Baffinland Iron Mines Corporation

Mary River Project, Baffin Island, Nunavut

**Milne Port-Tank Farm
Extension
Electrical Grounding Asbuilt**

Request for Information Documentation

RFI

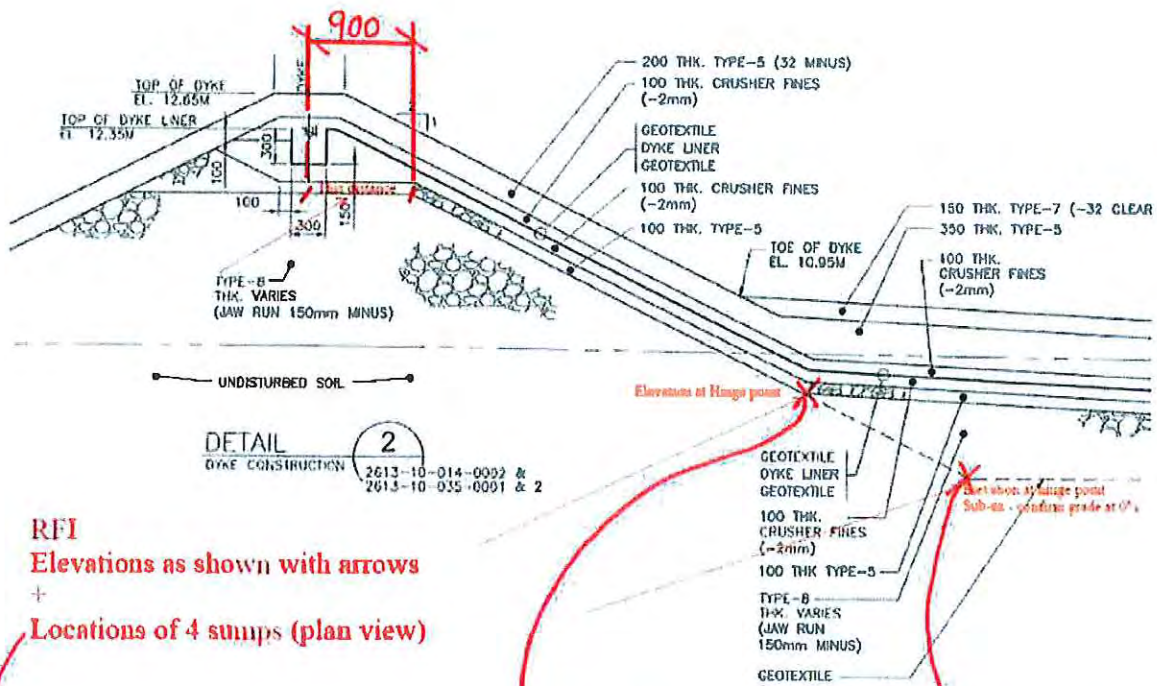
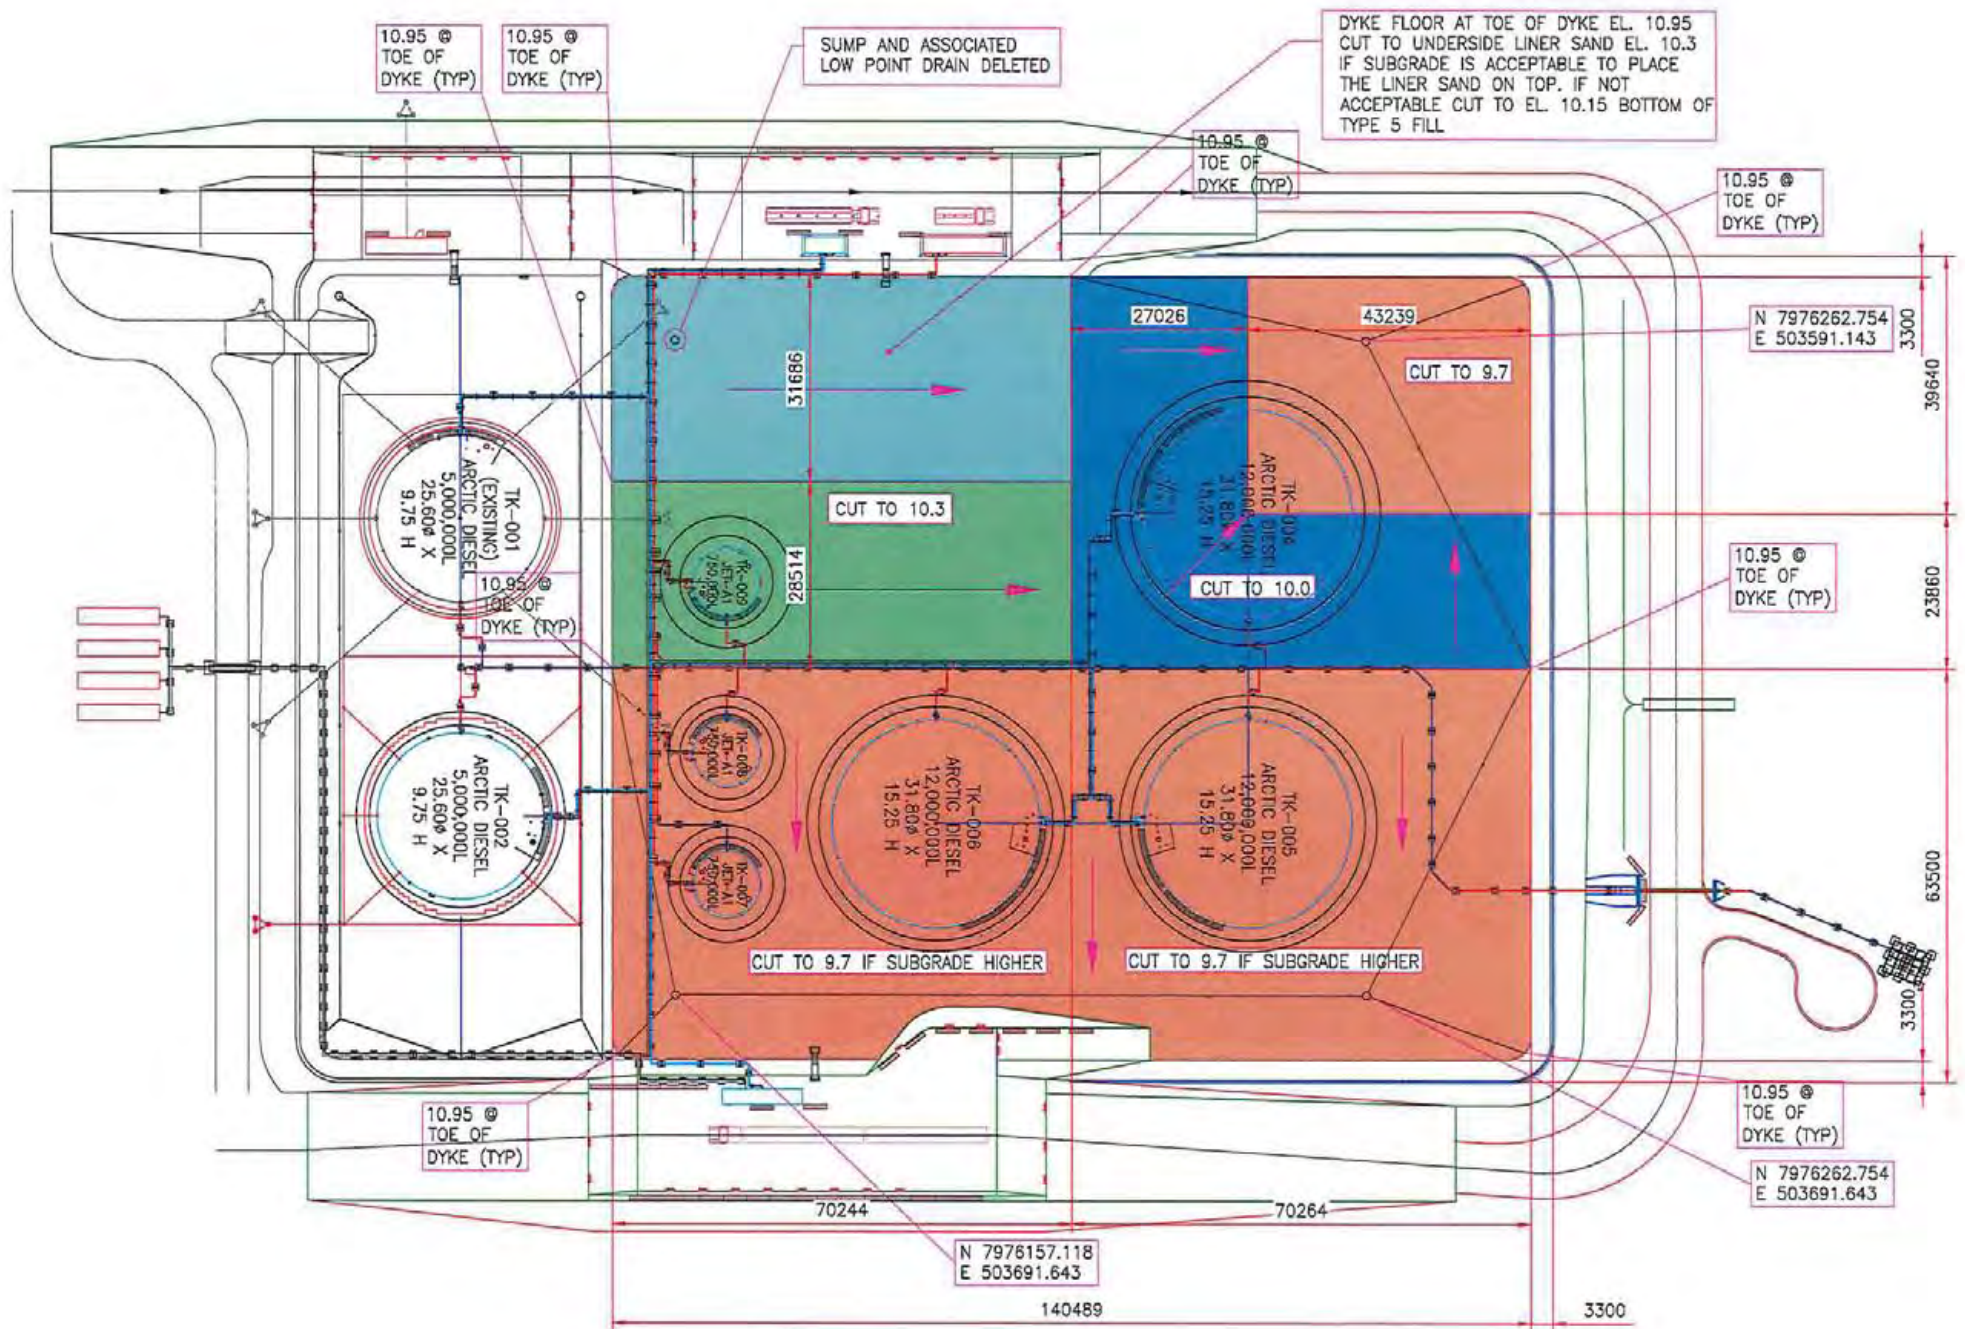
Information Request/Description of Issue/Approval Required: Please provide requested dimensions.
Proposed Corrective Action: Obtaining 3D models digital CAD models would certainly help, if available in CAD or LandXML format.
Originator: Nuna
<i>Print: Kyle Kuntz Sign: Date: June 04, 2013</i>

Please see markup and sketch attached for requested dimensions. Attached sketch also confirms required cut elevations for full tank farm pad. Please note deletion of one sump. Revised drawings will follow. 3D digital models of the dike are not available.		
Responsible Engineer: James Cleland / Eric Bond	June 6, 2013	
Print:	Sign:	Date:

Elevations as shown with arrows

Locations of 4 sumps (plan view)

Notes

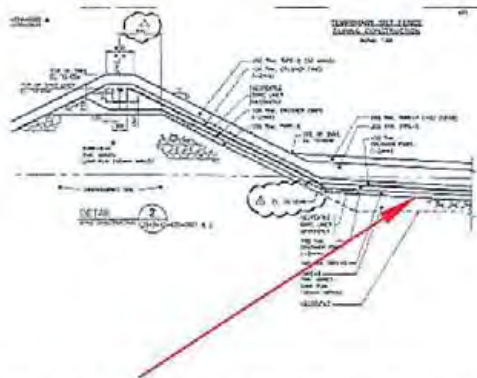
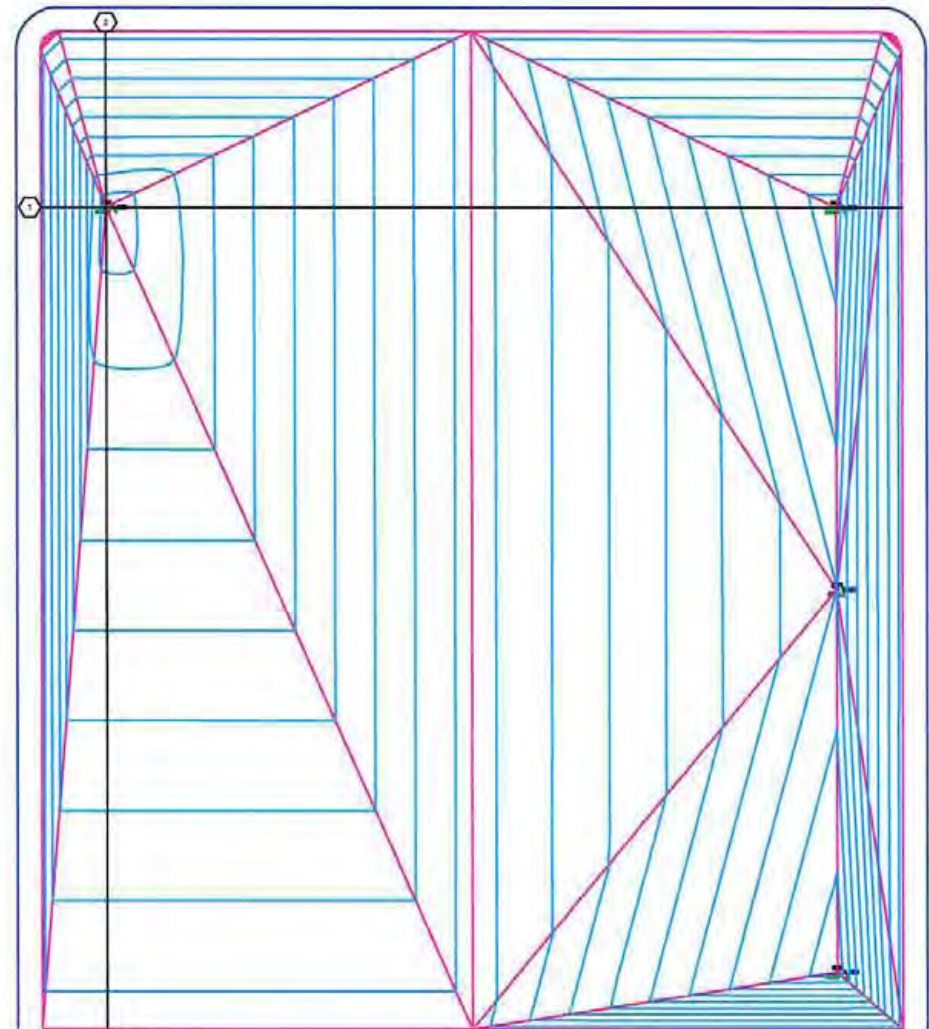
Information Request/Description of Issue/Approval Required:
1. At locations within the Containment Dyke the proposed subgrade elevations 9.7, 10 and 10.3 conflict with the underside of Type 5 material level (see attached sketch). Please confirm that the subgrade elevation in these areas will be controlled by the underside of type 5 material surface. 2. With the 3D digital models for the Dyke unavailable for reference and the generation of our layout files, please confirm that the attached cad layout file completed from the pdf IFC's (with assumptions) for the underside of the Type 5 material adheres to the design requirements. 3. At locations within the Containment Dyke the thickness for the Type 8 (Jaw Run) placement is too shallow to allow for the minimum lift thickness of the material.
Proposed Corrective Action:

3. Nuna is proposing the use of Type 5 (32mm) material in place of the type 8 material for areas that the lift thickness does not allow for use of the type 8.
Originator: Nuna
Print: Mike Price Sign: Date: June 17th, 2013

1. In areas of good quality subgrade (well graded and compacted material) with no large rocks excavation is only required to the underside of the crusher fines / sand bedding. In areas of poor subgrade excavation is required to the underside of the type 5. In all areas excavation must be at or below the specified subgrade elevations (ie. excavate to specified elevation or, where required, lower).
2. The supplied cad files correctly interpret the design intent.
3. Type 5 material may be substituted for type 8 material where required.

This top of type 8 (Jaw Run) floor surface is based the following elevations:

2. Three (3) Sumps location each assigned with an elevation of 9.665m. This elevation determined from the following calculation:

Bottom of swale 10.165m - 500mm = **9.665m**

Dyke low point 10.45m - 800mm = 9.65m

Note. Dyke low point value of 10.45m removed from IFC version 1. This value however used as a check on determination of distance from bottom of drainage swale (10.165m) to bottom of type 5 under the sump; as this distance could not be found on the drawing.

3. A longitudinal North-south break line with a value of 10.121m at midpoint of the dyke for high point.

4. A high point at the swale on the east side of the dyke with a determined elevation of 9.800m. 10.300m - 500mm.

TANKS TK-008
& TK-009

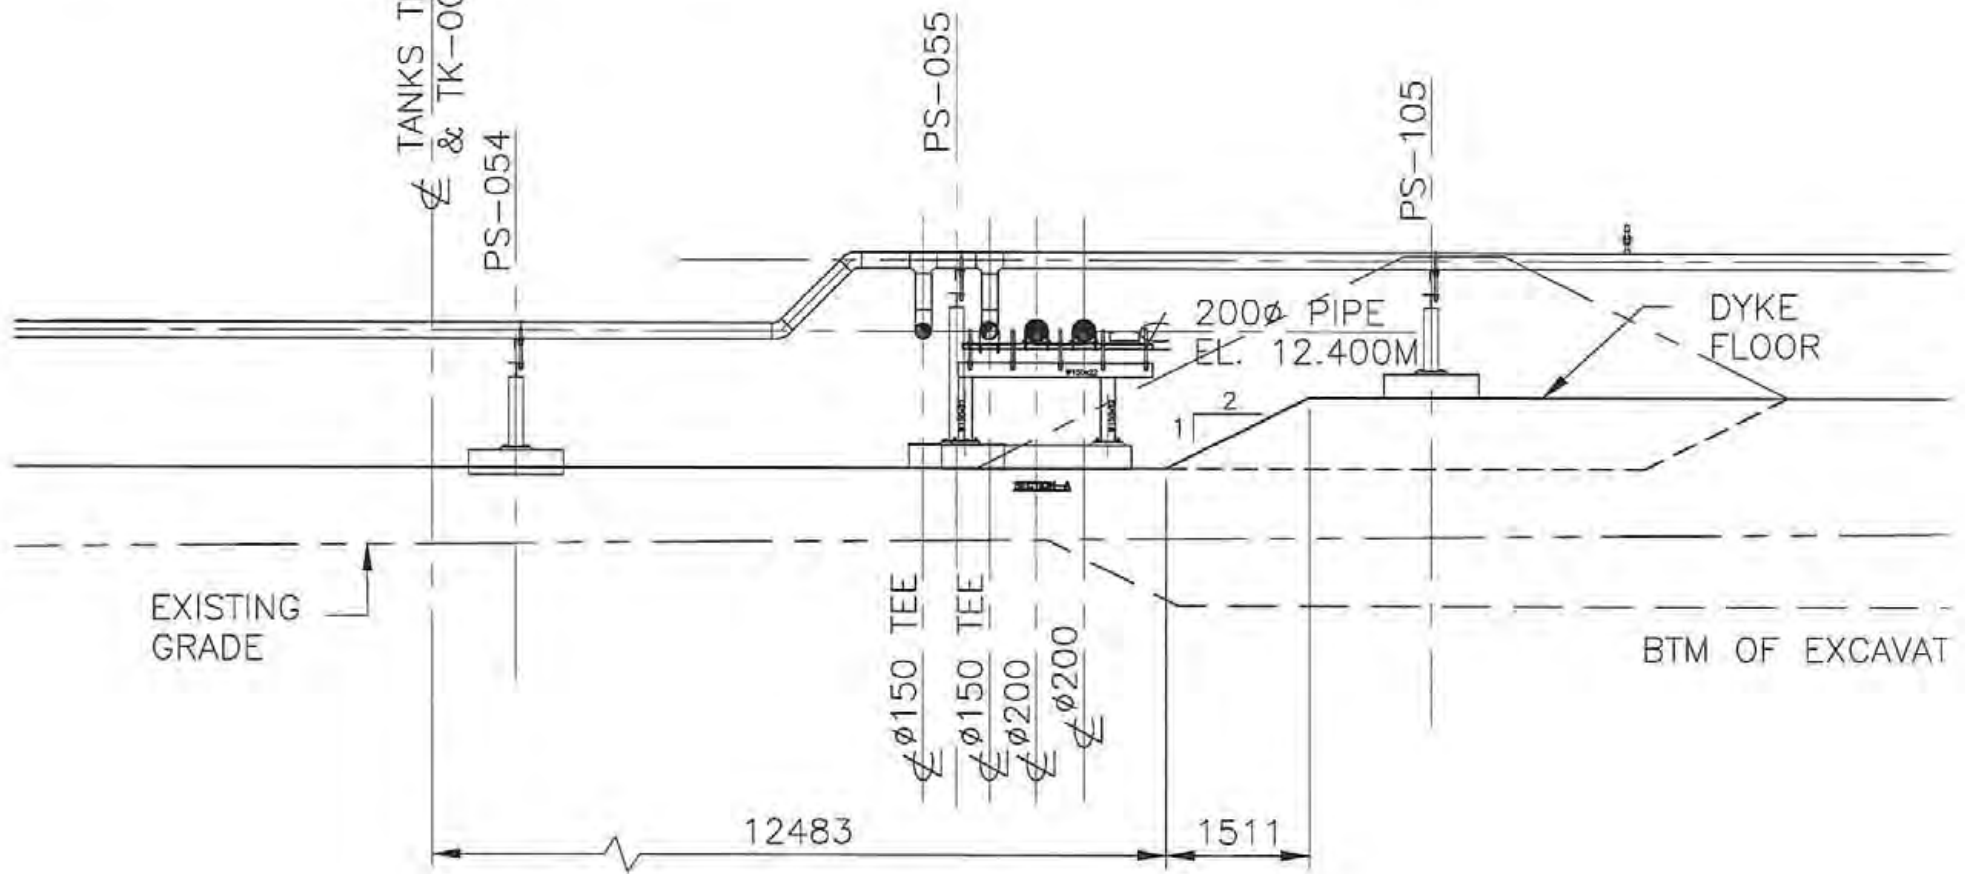
Information Request/Description of Issue/Approval Required: During the initial subgrade excavation a large amount of permafrost was encountered along the south edge of the dyke expansion where it meets the existing berm. It is suspected that permafrost will also be present within the footprint of the existing berm that is required to be removed for the liner tie in, slowing down the process.
Proposed Corrective Action: In an effort to minimize the amount of permafrost required to be removed, Nuna is proposing that the subgrade elevation within the berm footprint be raised to the elevation of the underside of sand bedding at the existing containment dyke. (see attached sketch)
Originator: Nuna <i>Print: Mike Price</i> <i>Sign:</i> <i>Date: July 8th, 2013</i>

The toe of the existing berm must be partially excavated to the new dike floor level however some of it may be left at the elevation of the existing dike floor. See attached sketch for dimensions		
Responsible Engineer:	J Cleland	12 July 2013
<i>Print:</i>	<i>Sign:</i>	<i>Date:</i>

See attached sketch
for required dimension
to toe of transition
